Campaign No. 2021070026, July, 2022

SUBJECT: **Model 907 Sprinter, Model Year 2020
Software Update**

SM54.21-D-0229SG	Update software of control units (code: VS3MOGE20, acc. no.: 07 972 77)	26.07.2021
-------------------------	--	-------------------

D54.21-A036-76

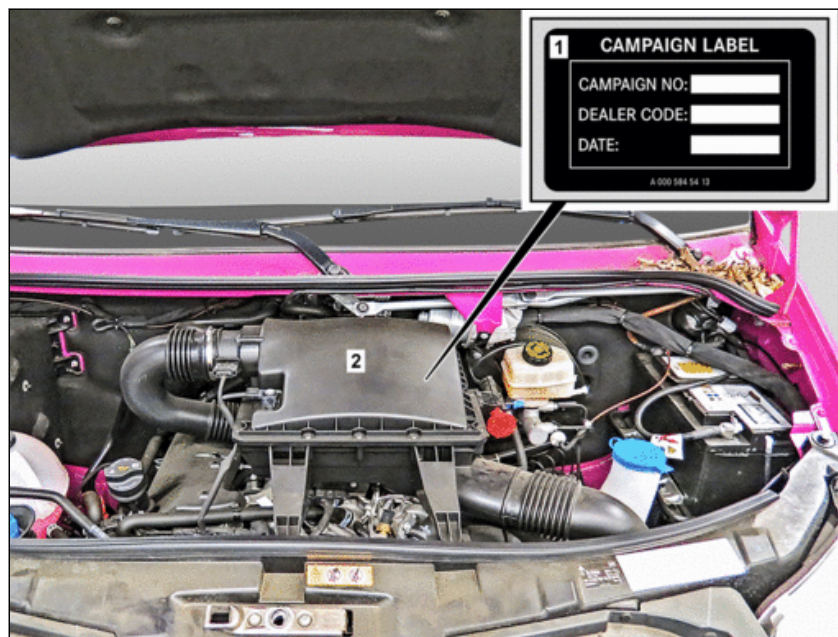
5	Update software for fully integrated transmission (VGS) control unit (N15/11).	 It is absolutely essential to precisely follow the operation steps as described in the vehicle diagnosis system.	
6 	Disconnect diagnostic system.		AD00.00-D-2000-06TS
7 	Remove charger from vehicle.		AR54.10-D-1127TS
8	Fill out campaign label (1) and attach to air filter housing (2).	Only applies for vehicles in State of California.  Bonding surface must be absolutely free of dust and grease. Otherwise, a sufficient degree of adhesion cannot be assured.  To do so, enter 6-digit campaign number, dealer code and date. Cleaner	BR00.45-Z-1025-04A
9	Fill out certificate and hand over to customer.	Only applies for vehicles in State of California.  Apply number from campaign label (1).
